PROYECTO DE MODERNIZACIÓN REFINERÍA TALARA (PERU)	
		SCADA OVERALL NETWORK ARCHITECTURE	
TECNICAS REUNIDAS		02070-GEN-ELE-BLD-002	
FORMATO SIZE	A4	PROYECTO No. PROJECT No.	02070
ESCALA SCALE	NONE	PLANO No. DWG No.	02070-GEN-ELE-BLD-002
		HJEDA SHEET	06
		REV.	00

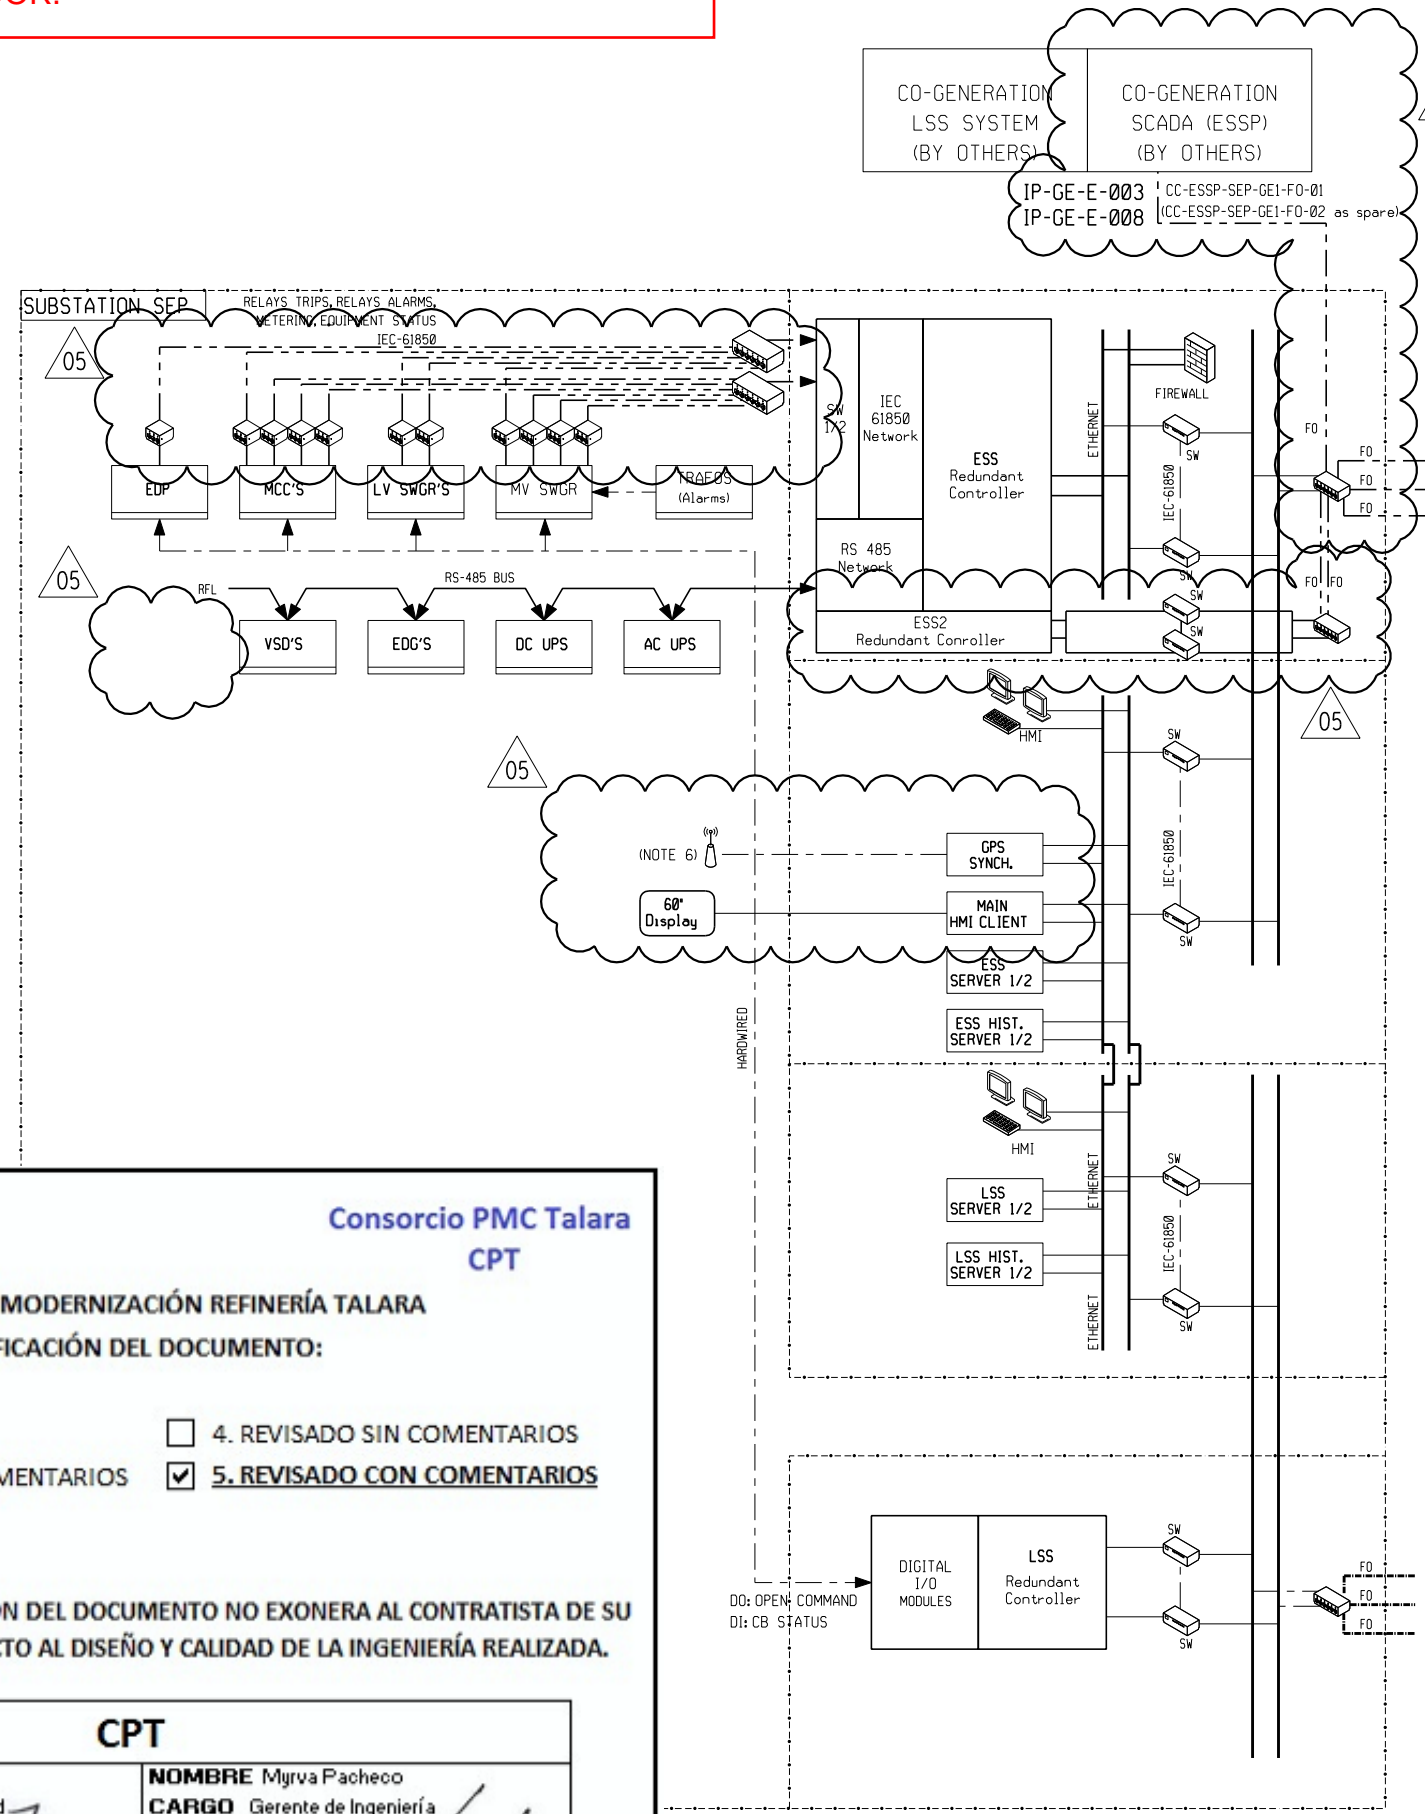
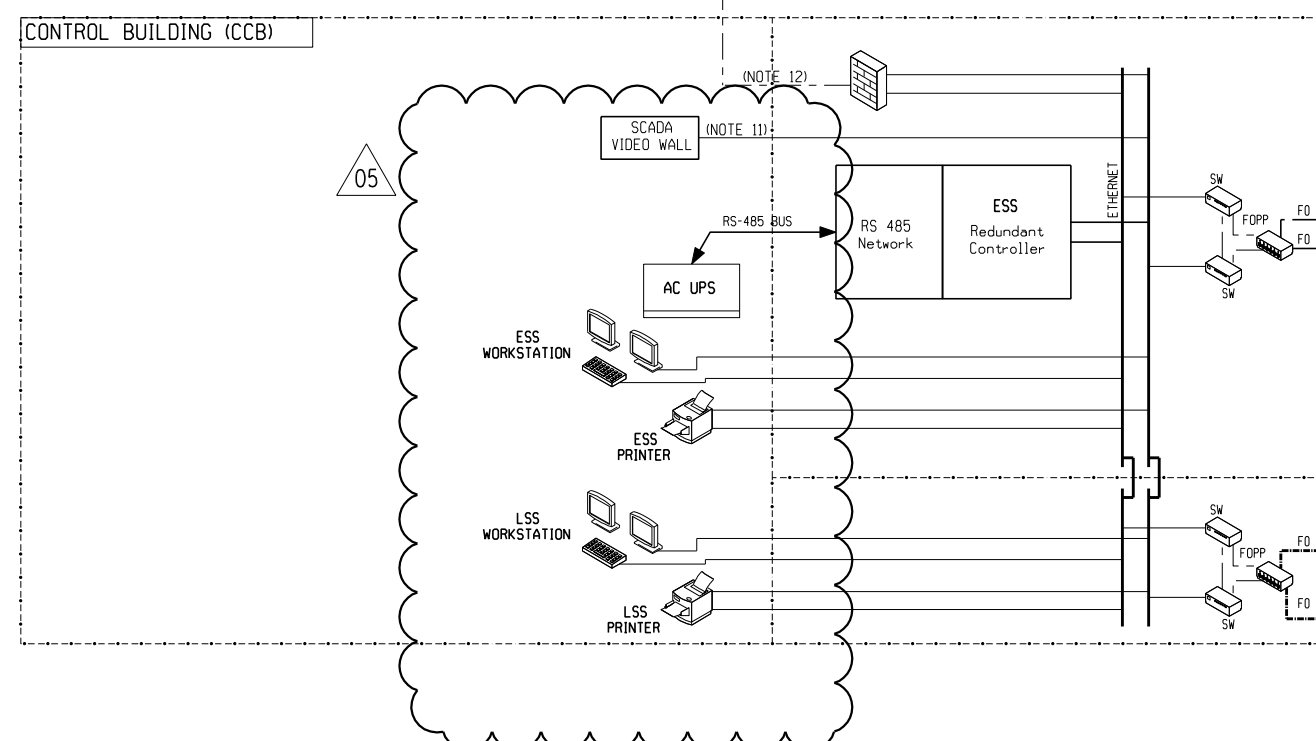
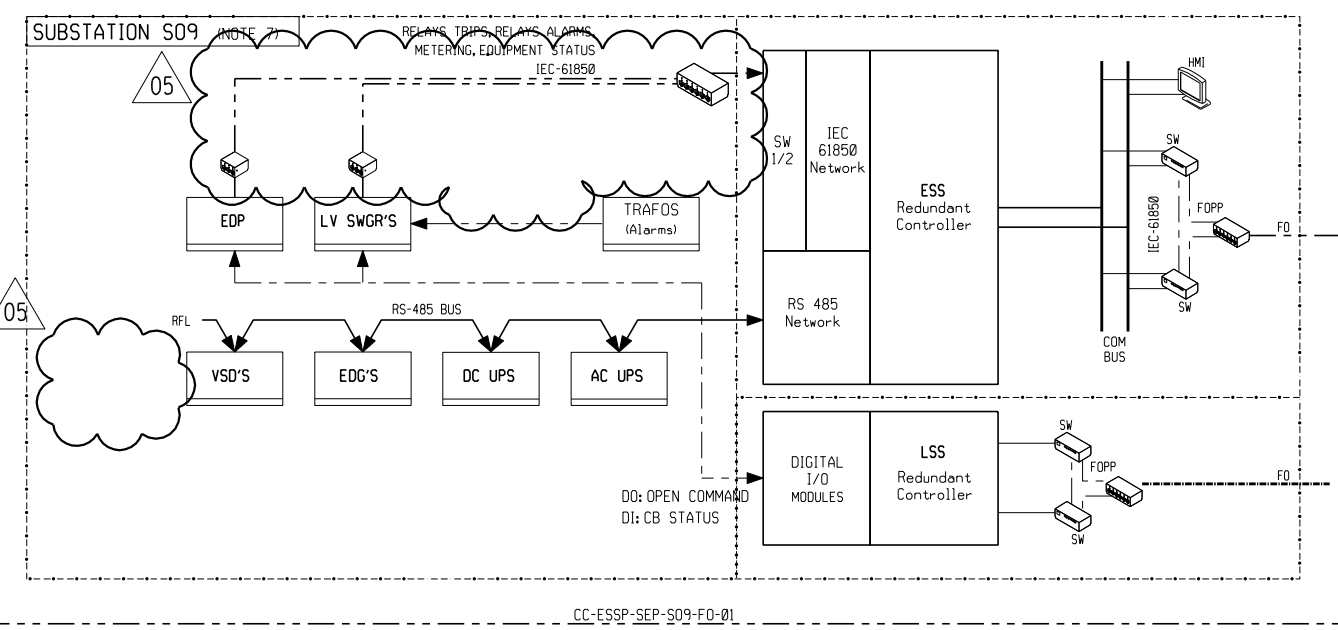
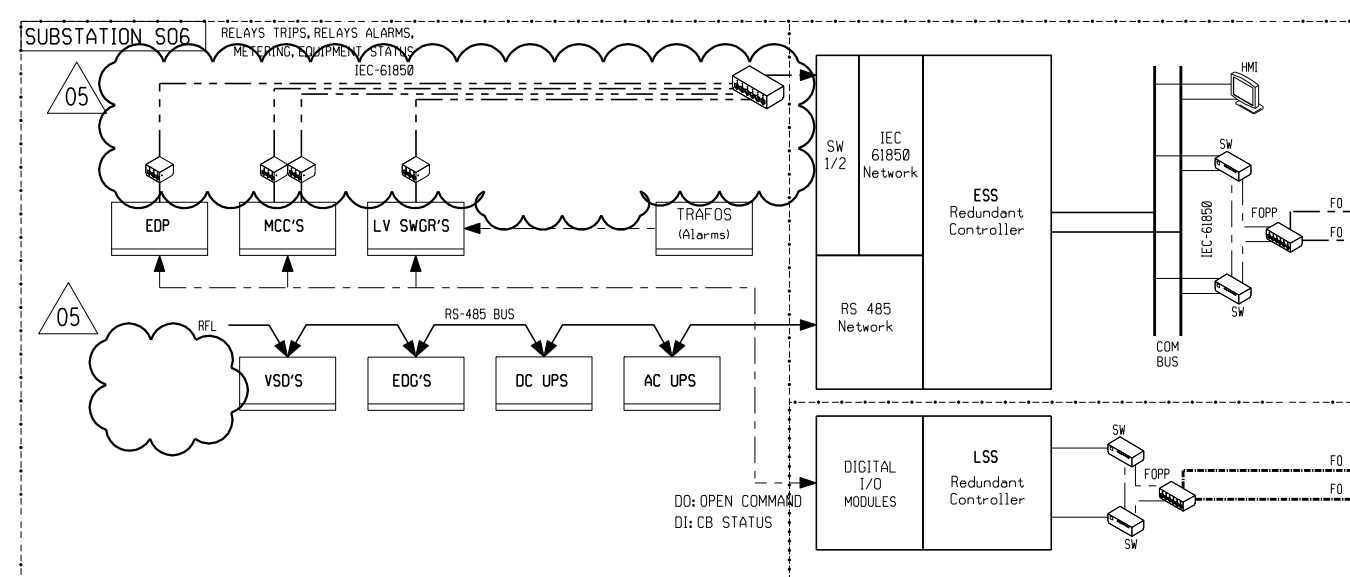
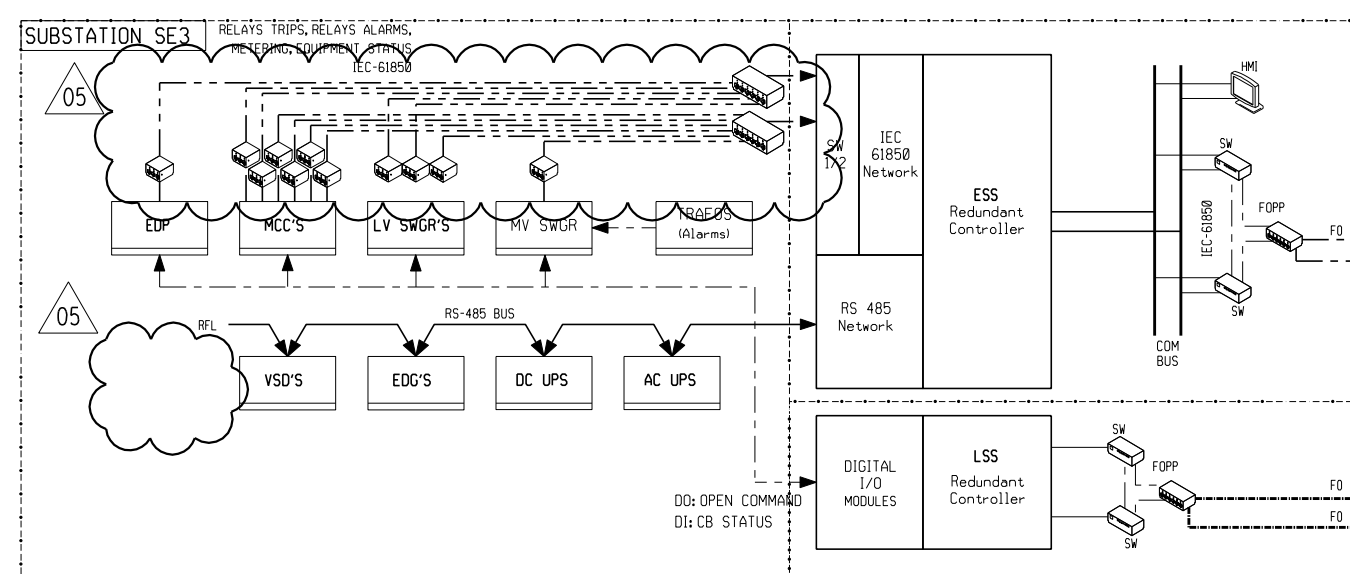
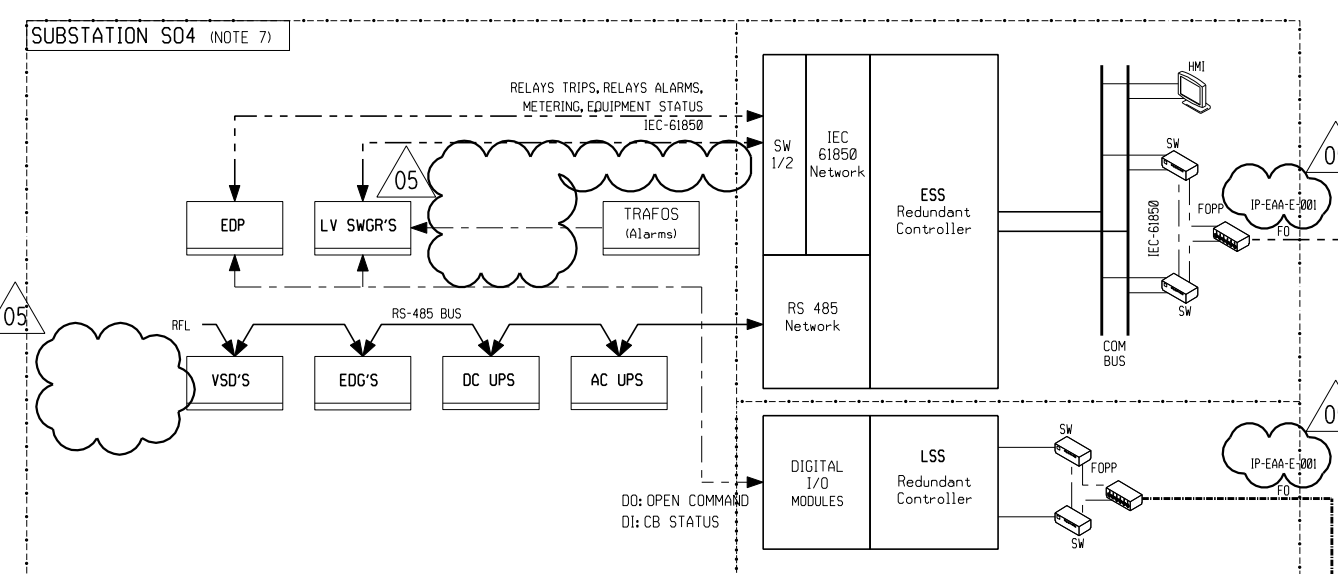
SE OBSERVA QUE SE HAN ELIMINADO LAS SEÑALES DE LOS HVACs, ASUNTO QUE NO HA SIDO APROBADO POR EL EMPLEADOR.
